**SAN JOAQUIN SOLAR 1 & 2 HYBRID
PROJECT
12-AFC-08**

**Supplemental Information
In Response To Cure Data Request Set #4**

September 23, 2009

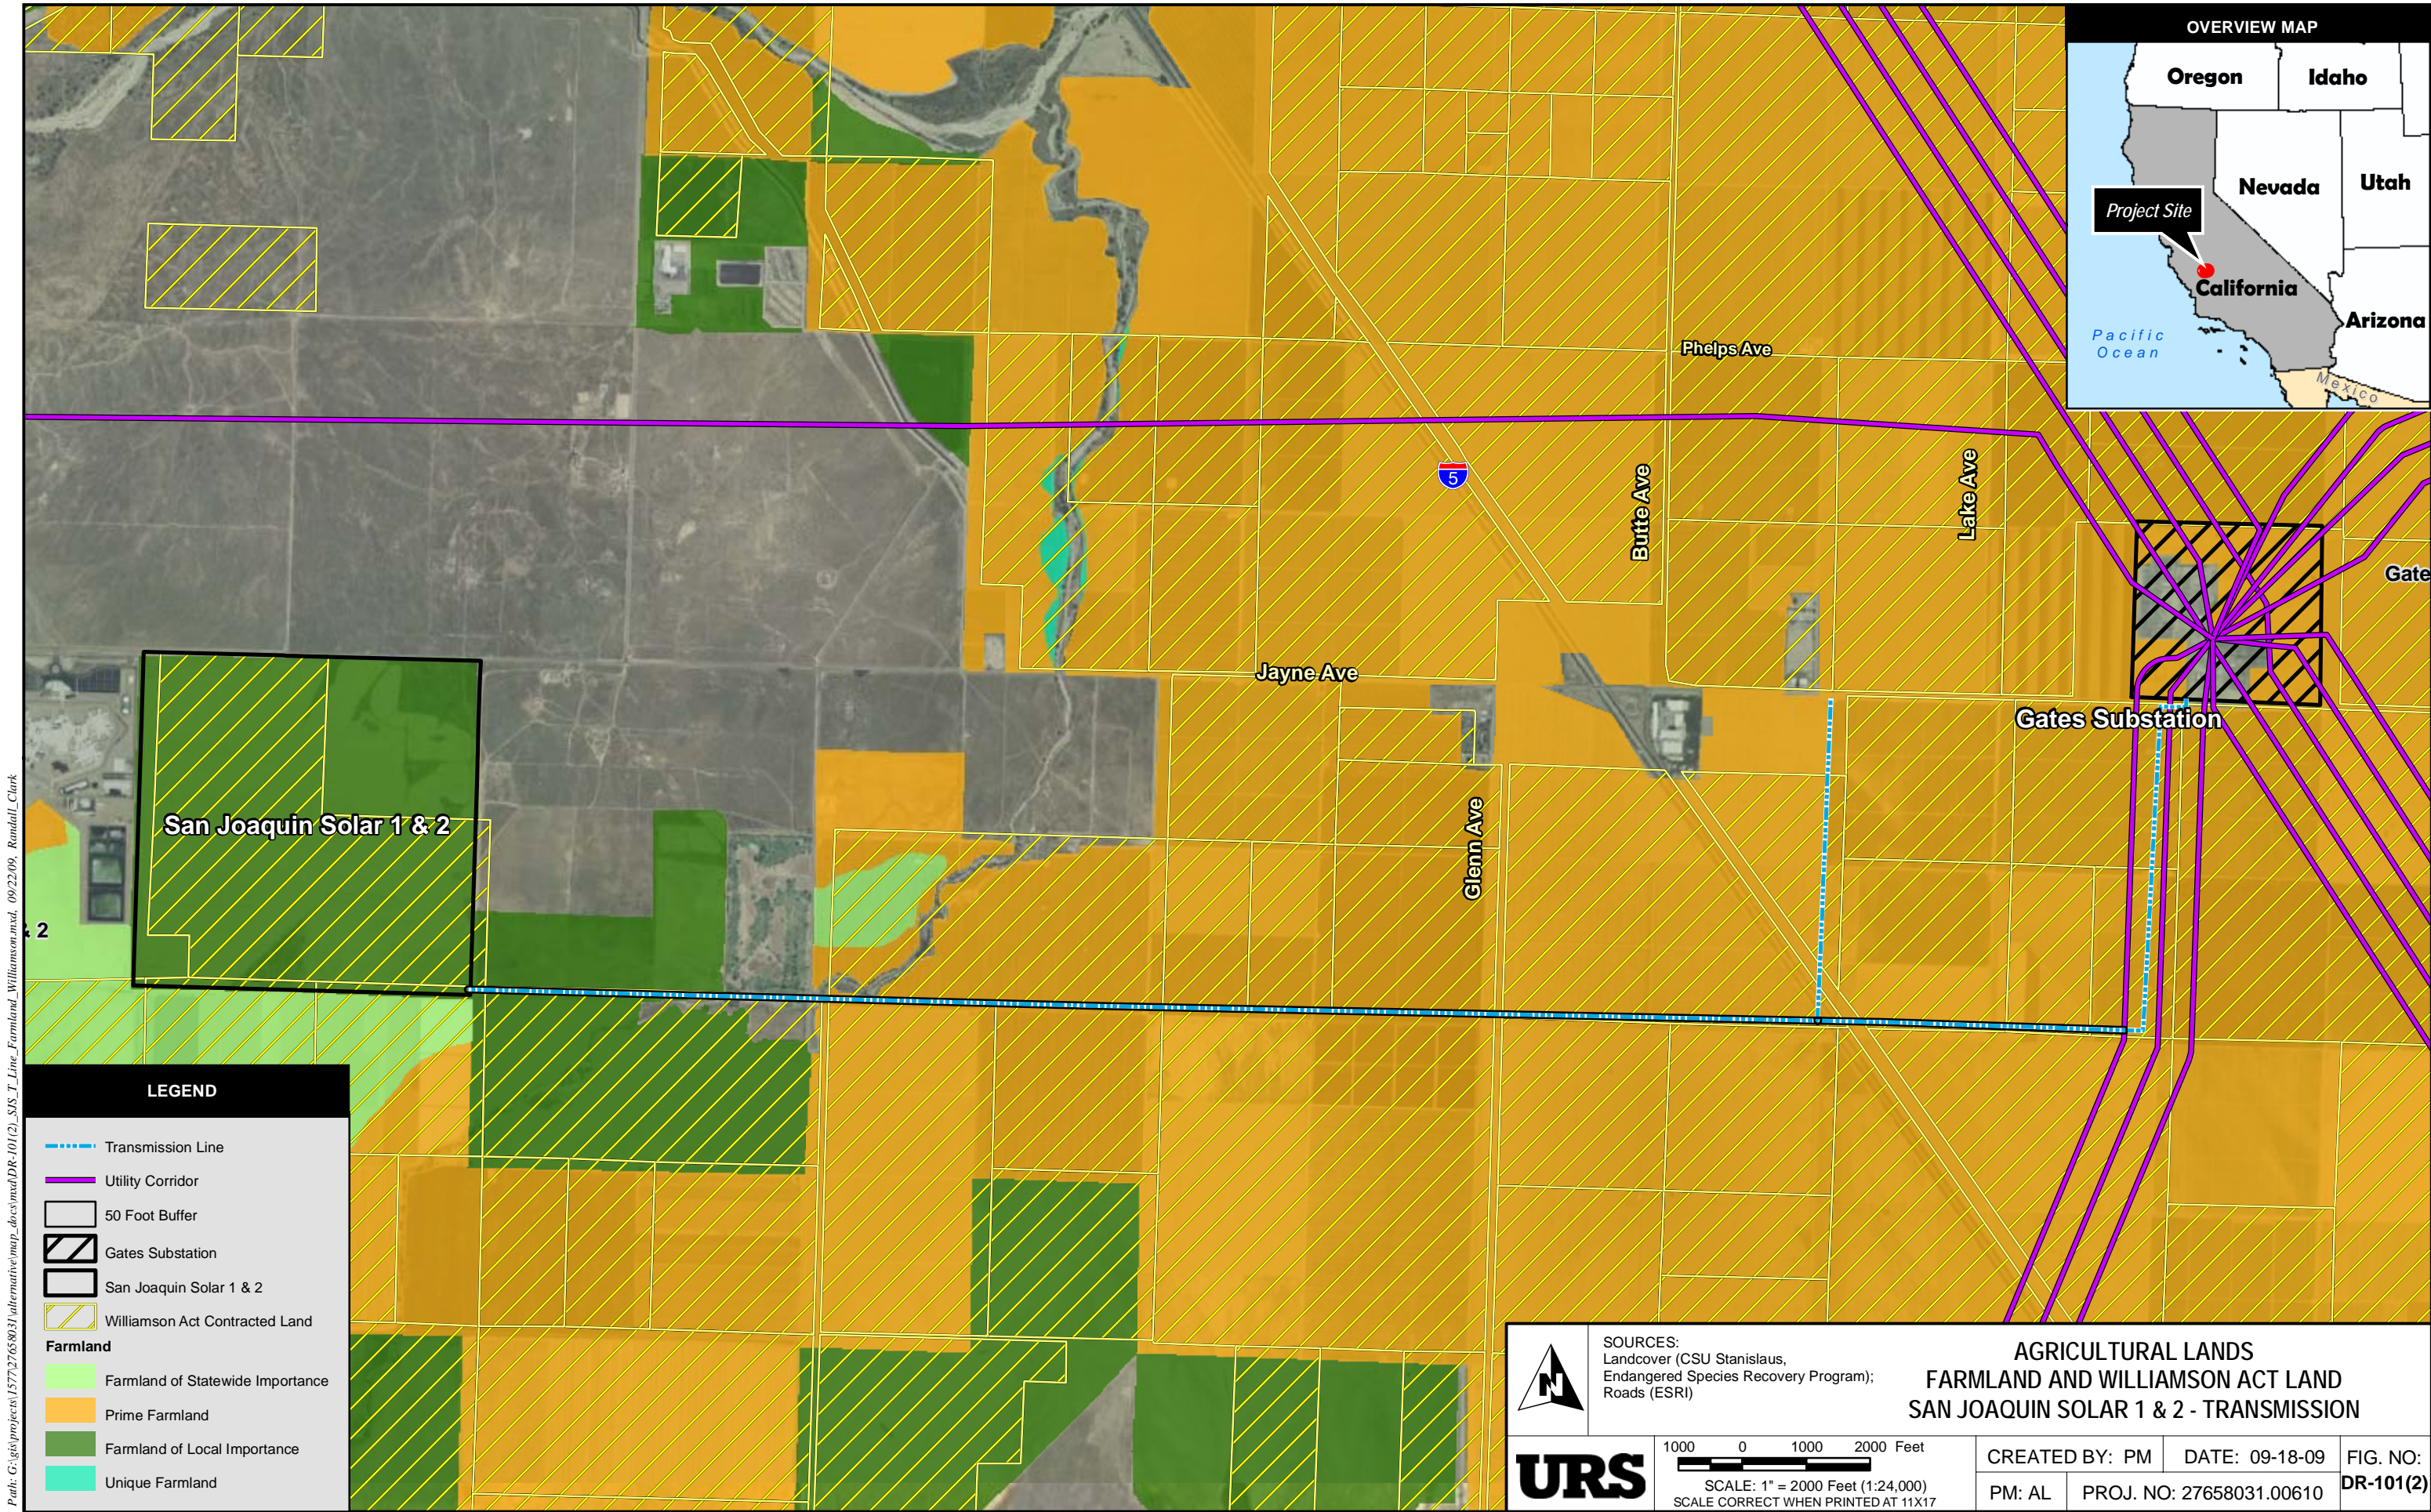
Data Request 103: Please provide documentation supporting the AFC's statement that the majority of the proposed transmission line alignment is comprised of orchards and row crops.

Response: Majority means more than 50%. As shown in Figure DR-103 less than one mile of the approximate 6 mile transmission line route is not comprised of orchards and row crops.

Path: G:\gis\projects\15772765803\alternative\map_docs\mod\DR-101(2)_SIS_T_Line_Farmland_Williamson.mxd, 09/22/09, Randall_Clarke

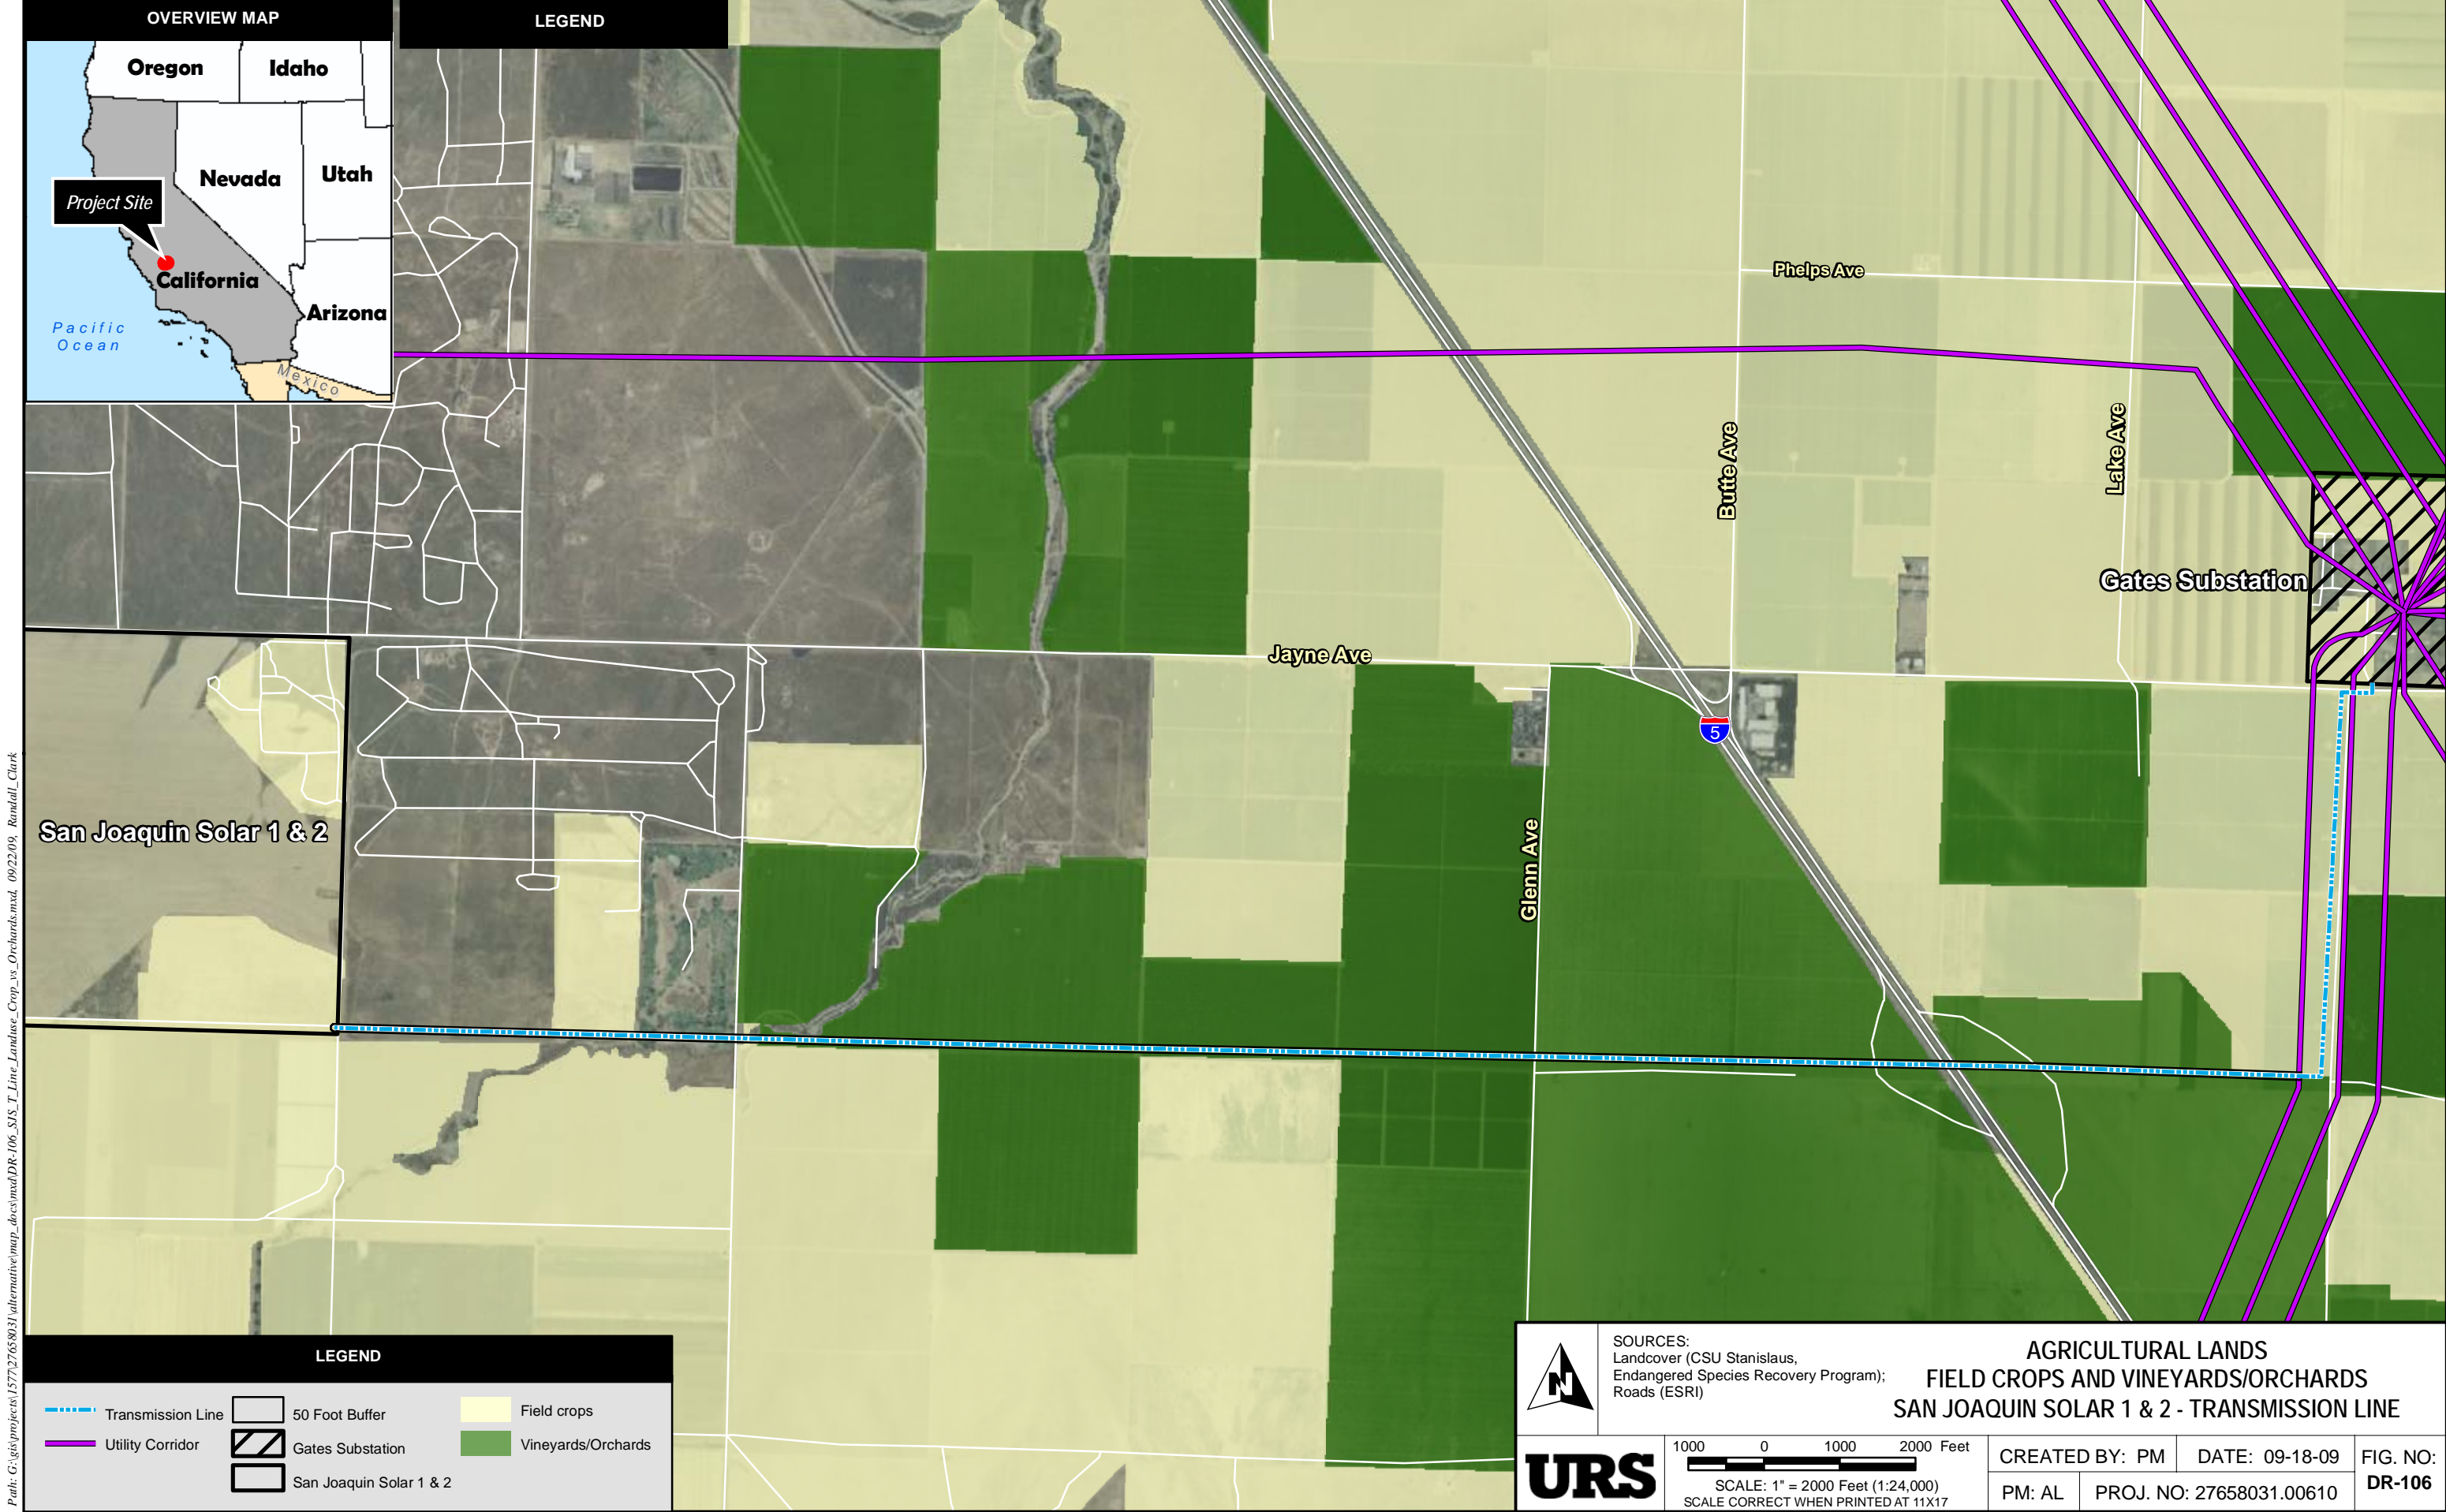
Data Request 101(2): Please explain whether the transmission line routes are on prime farmland, farmland of statewide importance, unique farmland, or farmland of local importance.

Response: As shown on Figure DR-101(2), the transmission line route is on a service road adjacent to approximately 5 miles of Prime Farmland and less than one mile of Farmland of local importance. However, it is not anticipated that agriculture would be impacted within the transmission route easement area, since cultivation may still take place. The transmission pole locations are most likely to be along the existing dirt road and will not occur on areas that are actively cultivated.
